Application Ref:
76034/APP/2020/4095

TOWN AND COUNTRY PLANNING ACT 1990 (AS AMENDED)
REFUSAL OF PLANNING PERMISSION

Conversion of roof space to habitable use to include, increase in ridge height, addition of pitched roof over flat roof element, a rear dormer and 1 front rooflight

Location of development: 96 Bourne Avenue Hayes

Drawing Title:
Proposed Roof Plan

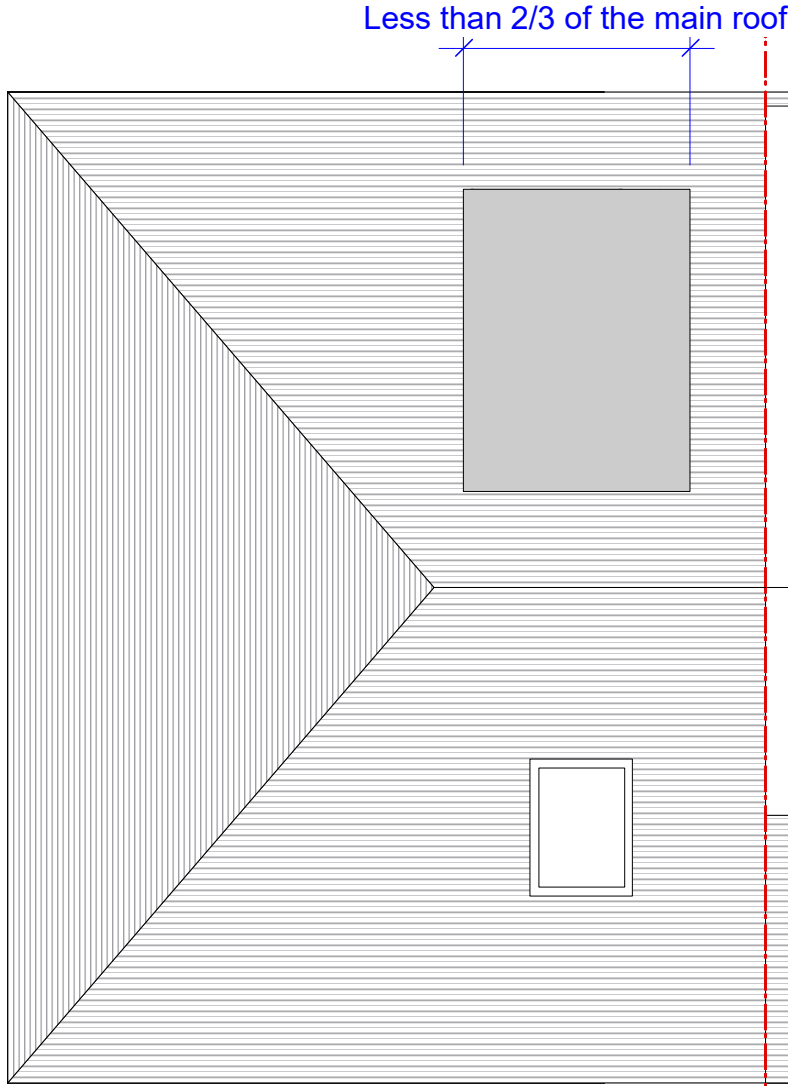
The proposed alterations to the roof, by reason of their size, scale, bulk and height, in this open prominent position, would result in the closing of an important gap, at first floor level, characteristic to the area, resulting in a cramped appearance. The proposal would therefore represent an overdevelopment of the site to the detriment of the visual amenities of the street scene and the character and appearance of the surrounding area. The proposed development is therefore contrary to Policy BE1 of the Hillingdon Local Plan: Part One - Strategic Policies (November 2012) and Policies DMHB 11, DMHB 12 and DMHD 1 of the Hillingdon Local Plan: Part Two - Development Management Policies.

The raised ridge to the roof, together with hip to gable conversion to one side and a rear dormer, would represent a significant change to the appearance of the application dwelling. The design would be considered unsympathetic to the host building and the greatly increased massing at first floor/roof level would make this a disproportionate and over-dominant addition that would be readily visible from the public realm. The height and massing of the proposed extensions would make it a visually prominent and incongruous addition to the host building. It would significantly reduce the sense of spaciousness, in this case at first floor level, to be found at this corner location, which is a characteristic feature of the area.

Drawing Title:
Proposed Elevation

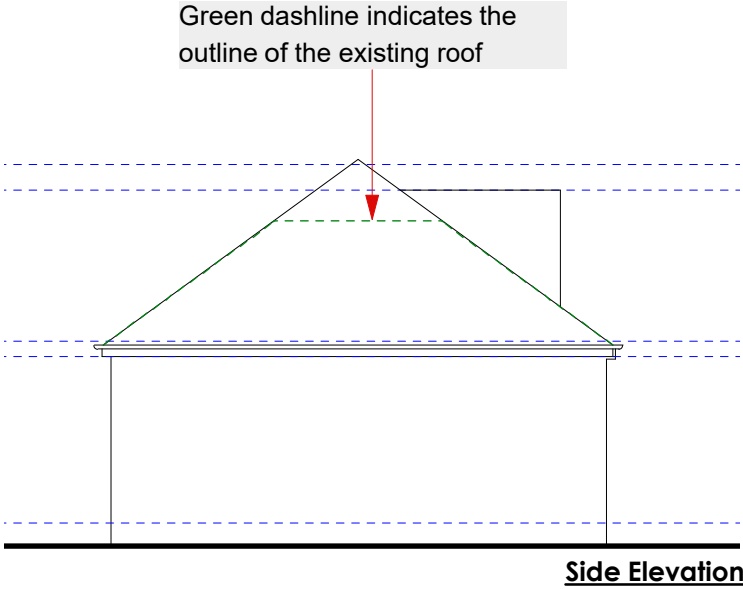
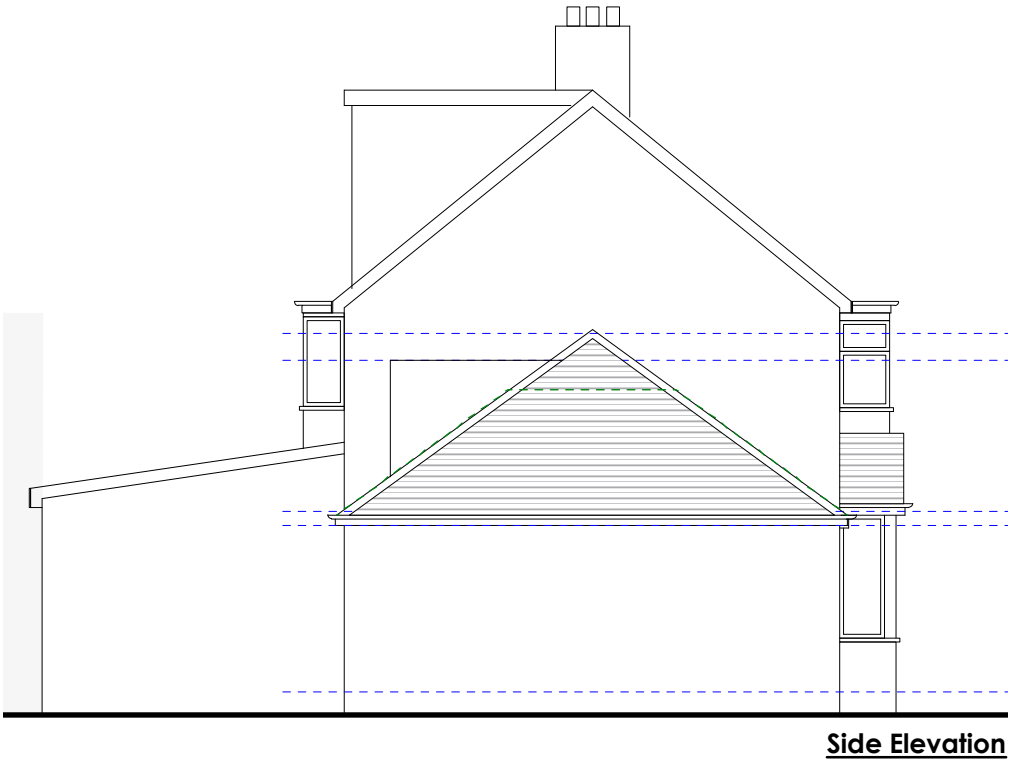
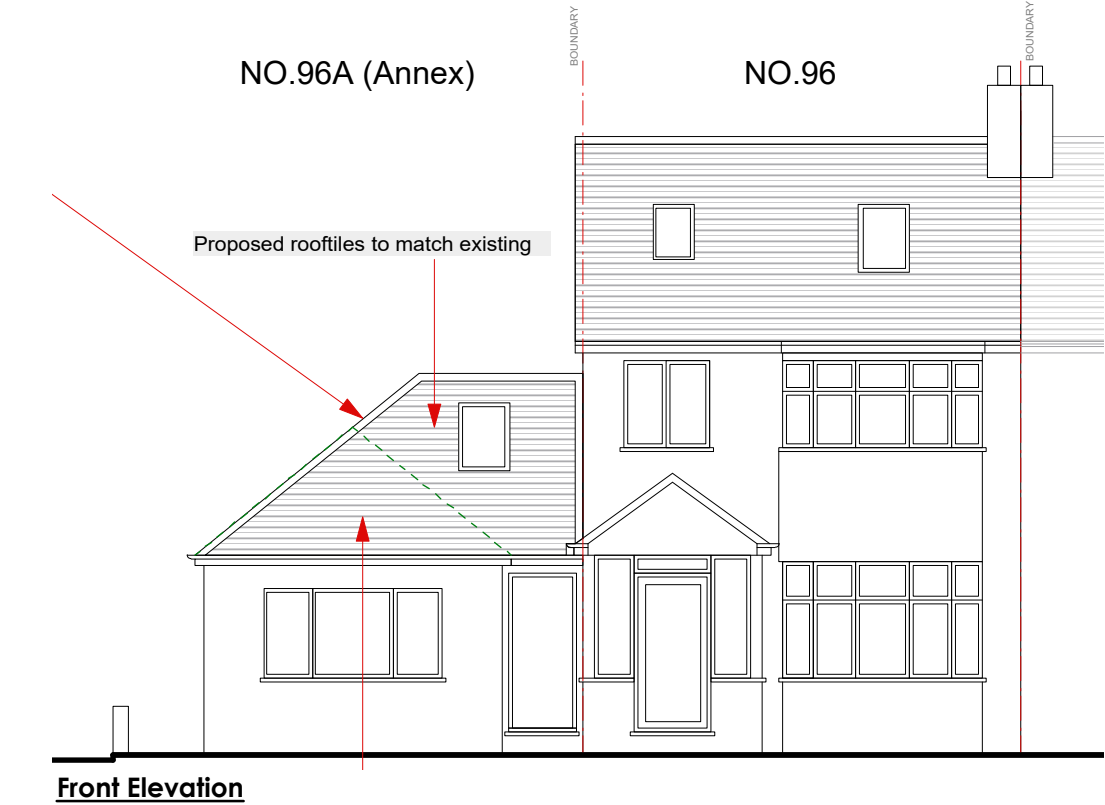
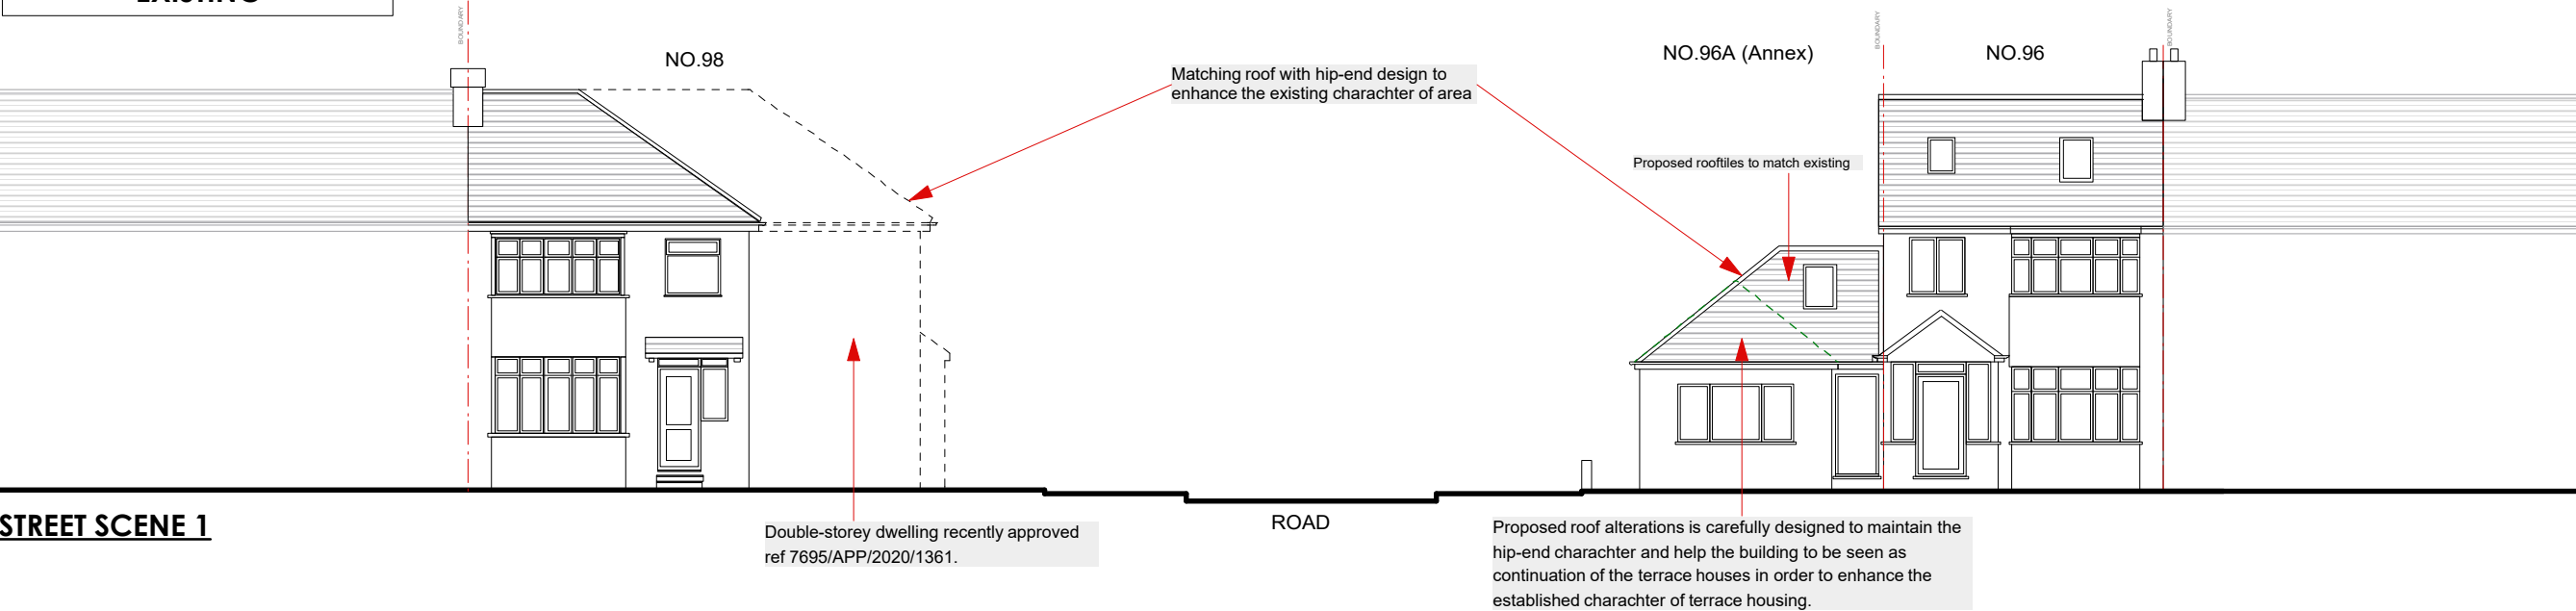
- 3 . The proposed roof alteration/extensions, by reason of the raising of the ridge height and the size, scale, bulk of the roof would fail to harmonise with the architectural composition of the original modest dwelling and would be detrimental to the character, appearance and visual amenities of the street scene and the surrounding area. Therefore the proposal would be contrary to Policy BE1 of the Hillingdon Local Plan: Part One - Strategic Policies (November 2012) and Policies DMHB 11, DMHB 12 and DMHD 1 of the Hillingdon Local Plan: Part Two - Development Management Policies (January 2020).

The proposed roof alteration/extensions, by reason of the raising of the ridge height and the size, scale, bulk of the roof would fail to harmonise with the architectural composition of the original modest dwelling and would be detrimental to the character, appearance and visual amenities of the street scene and the surrounding area. Therefore the proposal would be contrary to Policy BE1 of the Hillingdon Local Plan: Part One - Strategic Policies (November 2012) and Policies DMHB 11, DMHB 12 and DMHD 1 of the Hillingdon Local Plan: Part Two - Development Management Policies (January 2020).
